Addendum No. 3

June 9th, 2016

Project: Gallatin Valley YMCA

SHEET E302

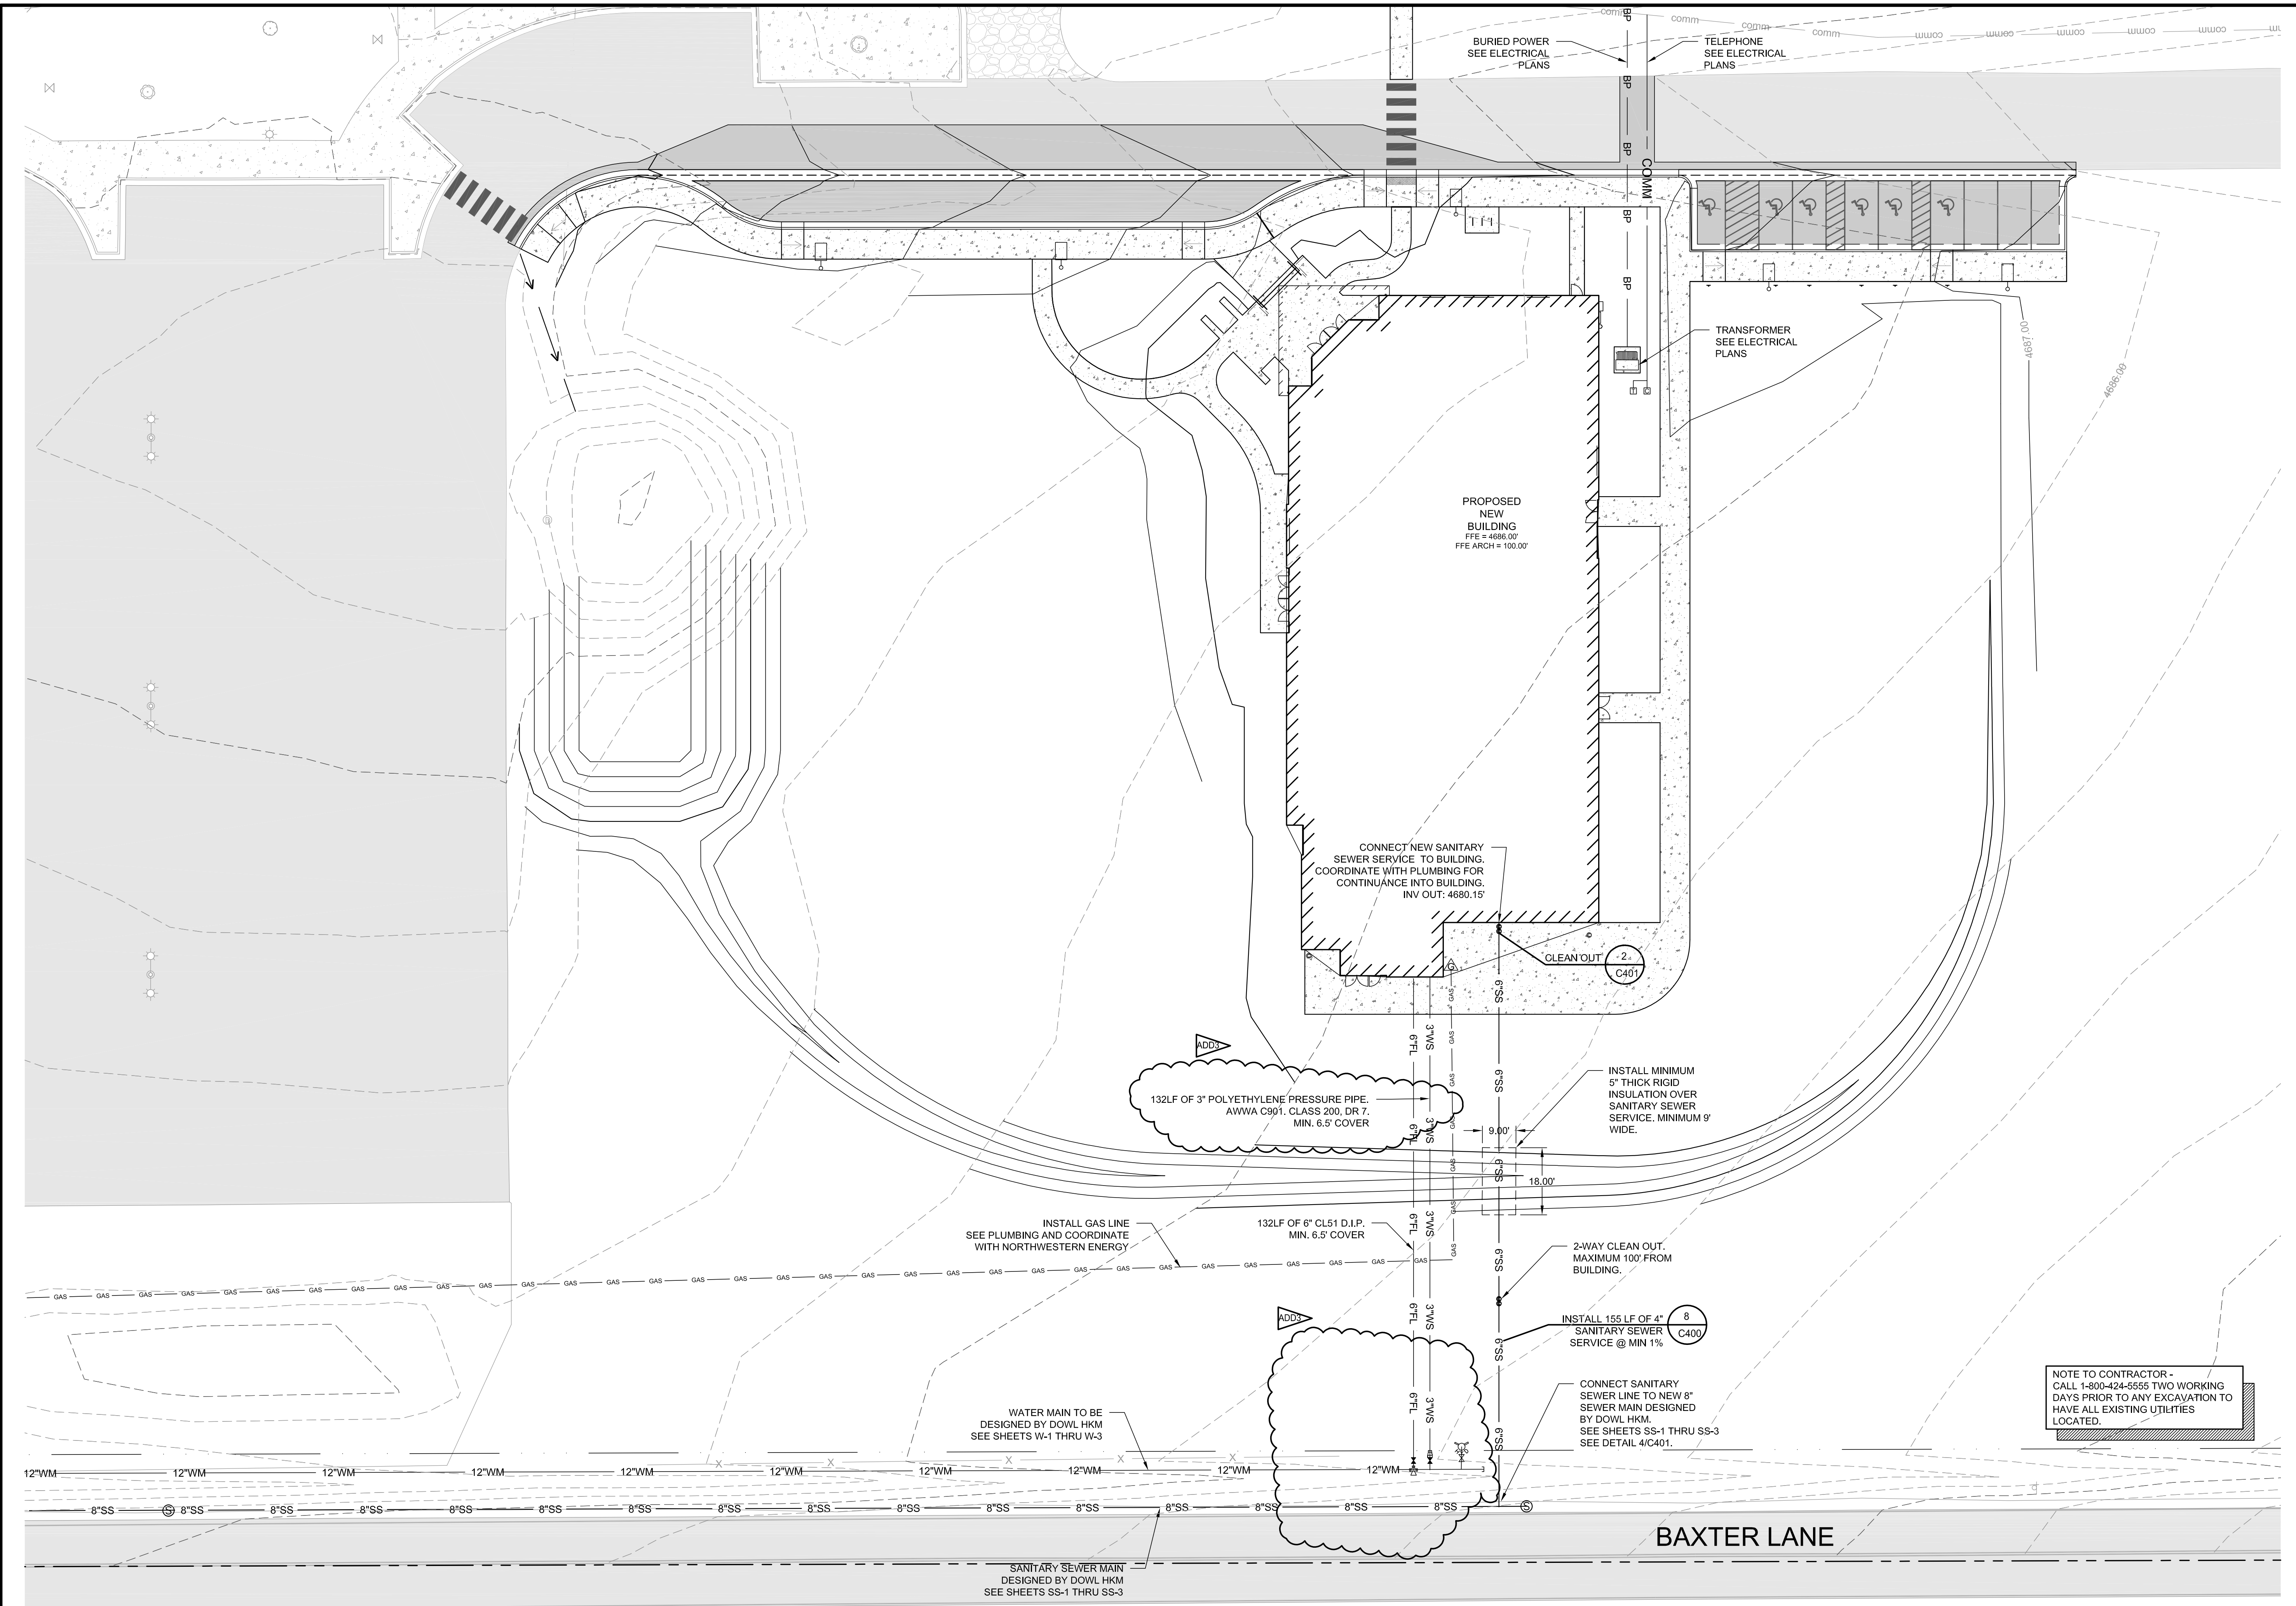
3. SHEET WORK NOTES – NOTE 3: Change COMBINATION FLOOR RECEPTACLE/DATA OUTLET TO A WIREMOLD SURFACE STYLE POKE-THRU SECTIONALIZED DEVICE RC4 OR AV3 SERIES OR EQUAL WITH 5-20R RECEPTACLE AND (1) CAT6 DATA PORT, GRAY COLOR. COORDINATE FINAL CONNECTION REQUIREMENTS WITH EXERCISE EQUIPMENT SUBMITTAL.

SHEET
A402

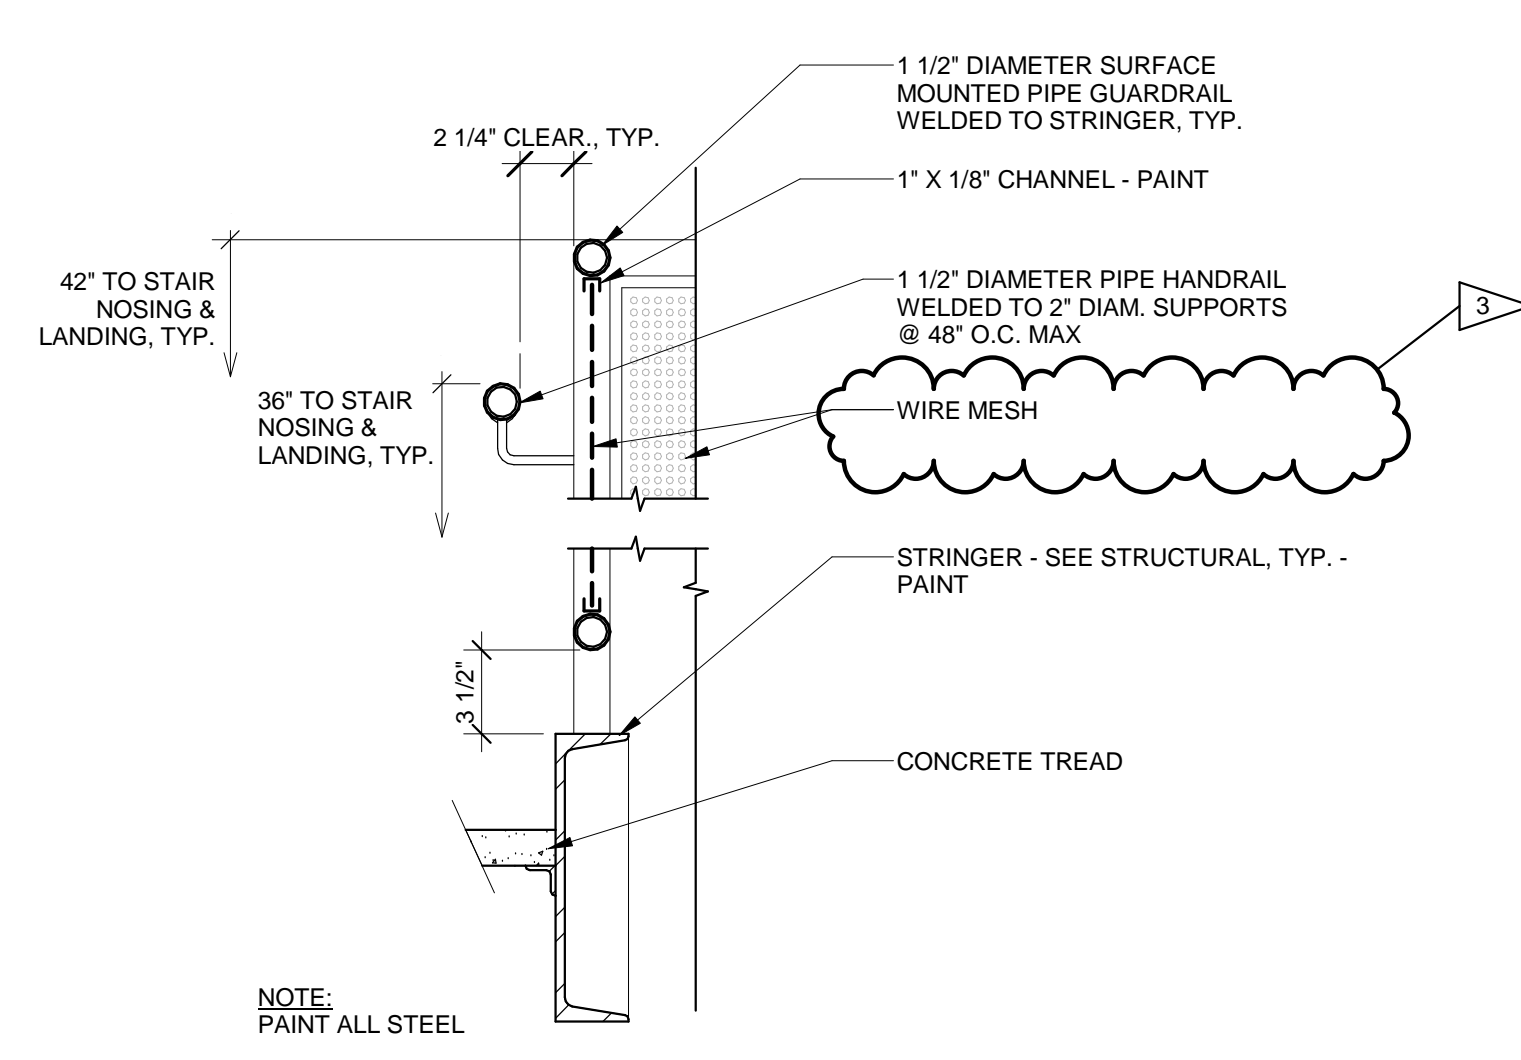
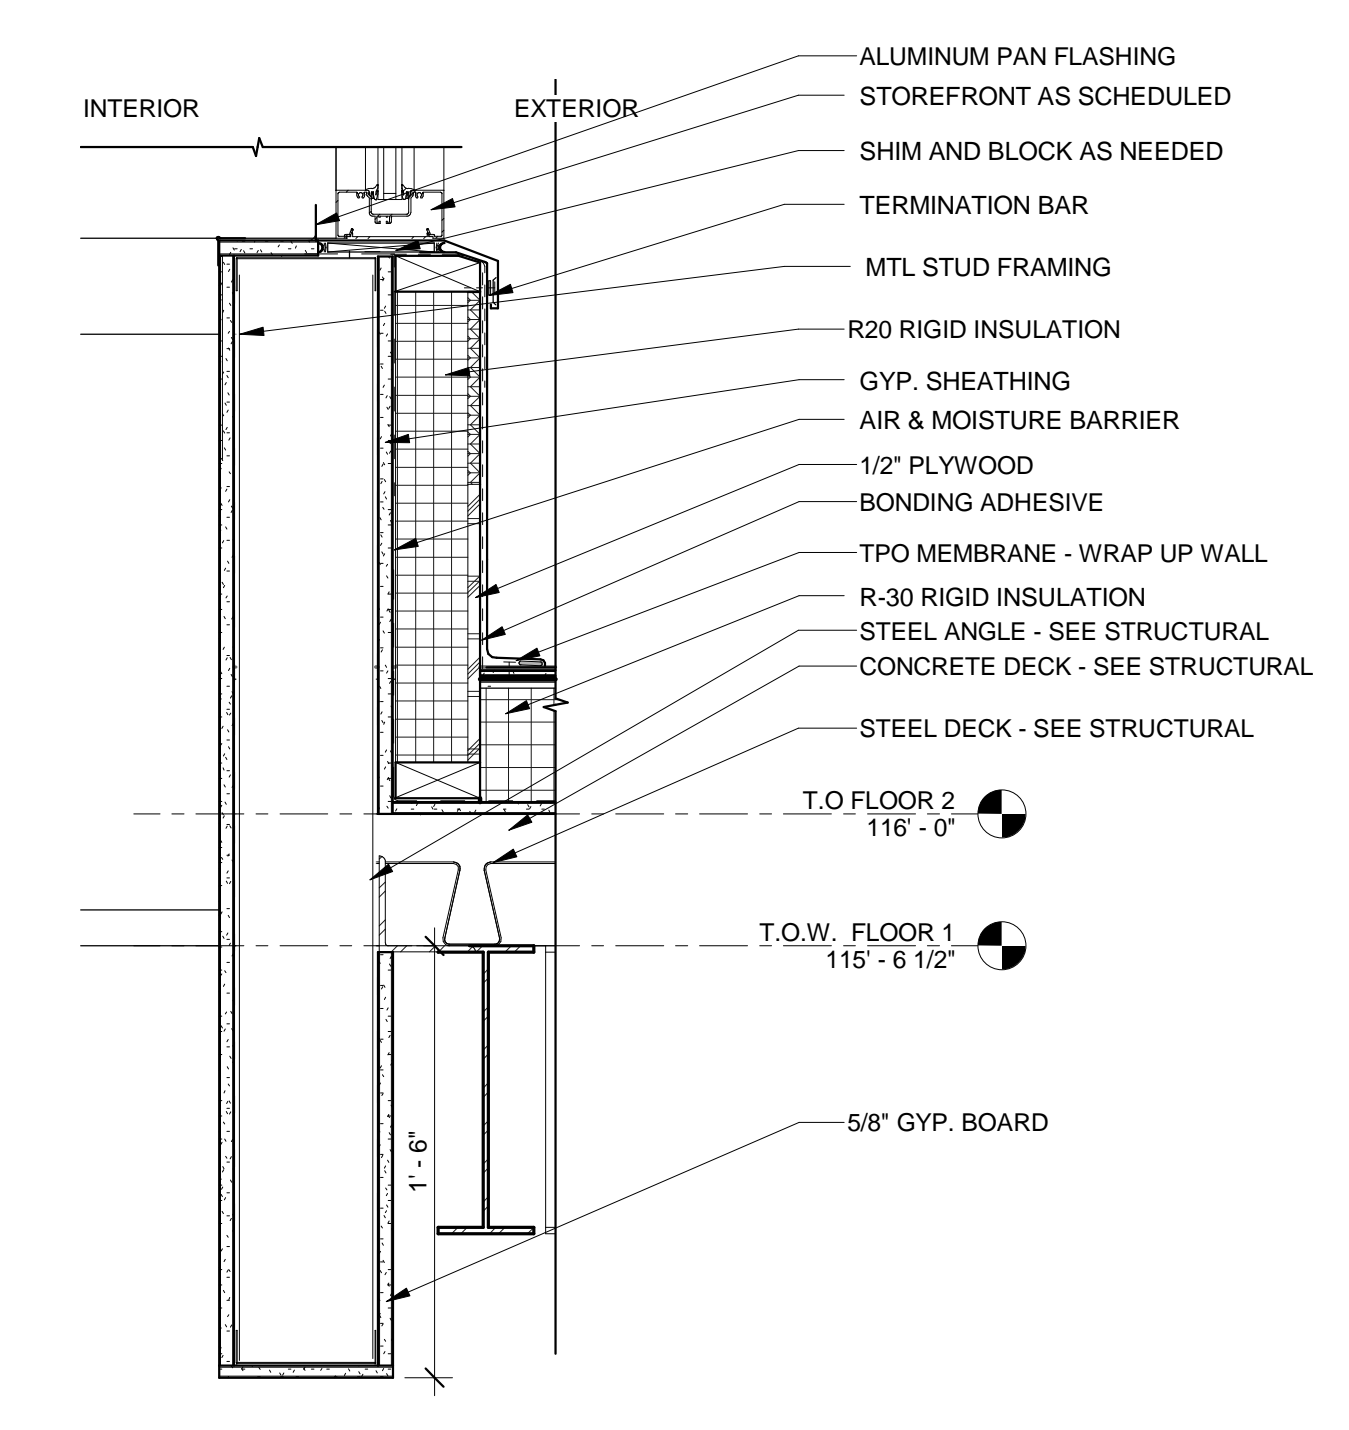
1. The following items are clarified in the revised sheets above and are narrated here for convenience: Central stair railing infill changed to wire mesh. See revised sheet A402. Interior windows V & W are to be Hollow metal. See revised A602 and additional detail on A604.
2. On Sheet A103, Notes 1 and 2, Change 30 mil Infiltration/Vapor Barrier to 10 mil Vapor Barrier.
3. On Sheet E201 and 202, Note that Fixtures called out as P3E are identical to P3 with the exception of added emergency battery backup.
4. Make the changes noted on the Electrical Sheets referenced below.
